South Cambridgeshire District Council

Responses to the Examining Authority's second written questions and requests for information (ExQ2)

Application by Anglian Water Limited for an Order Granting Development Consent for the Cambridge Waste Water Treatment Plant Relocation project (CWWTPR) (ref: WW010003)

Deadline 5

Appendix 1: Map 0

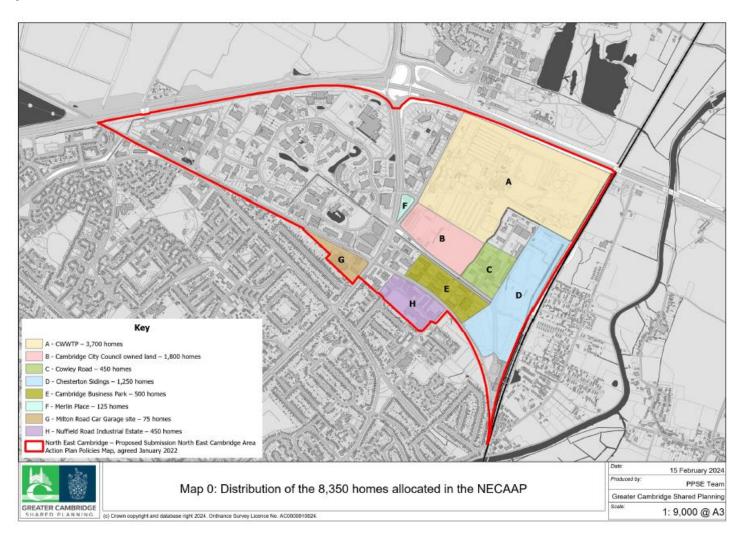
SCDC and CCC also propose that further text be included at paragraph 6.34 of both LIRs where the issue of dwelling numbers is first addressed, to explain the distribution and breakdown of the 8,350 homes allocated in the NECAAP, and in particular to clarify how many homes are assumed on the CWWTP site itself and the adjoining City Council owned land. It also clarifies the number of homes that are enabled by the relocation of the CWWTP. A new Map 0 is proposed to illustrate the distribution of homes. The changes proposed are as follows:

| 2. PRINCIP | LE (INCLUDING POLICY | Y AND LEGISLATIVE CONTEXT, NEED AND ALTERNA | Committee on the 24th January 2024 for employment development rather than residential))." A new Map, "Map 0", appended to this document is proposed to be included below, which shows the distribution of all the allocated homes more explicitly. For completeness SCDC and CCC request that a further amended version of their LIRs be allowed to be submitted that incorporates these changes. |

"6.34 The vast majority of the proposed allocation of 8,350 dwellings in the NECAAP are constrained by the presence of the CWWTP. There are a total of 6,925 homes within the odour contours that would be enabled by the relocation of the CWWTP. The areas identified for residential development are shown on the land use plan in the NECAAP as Figure 11 [Appendix 1 GCSP-7]. The NEC Typologies Study and Development Capacity Assessment (December 2021) [Appendix 1, GCSP- 19] includes Appendix A: Site Assessment Table that sets out the land parcels proposed for new homes. The distribution of housing is also shown on Map 0 below for completeness. The CWWTP site itself would accommodate 3,700 homes, whilst the adjoining land owned by the City Council would accommodate 1,800 homes, such that land being brought forward jointly by the Applicant and the City Council would deliver a total of 5,500 homes. The latest information
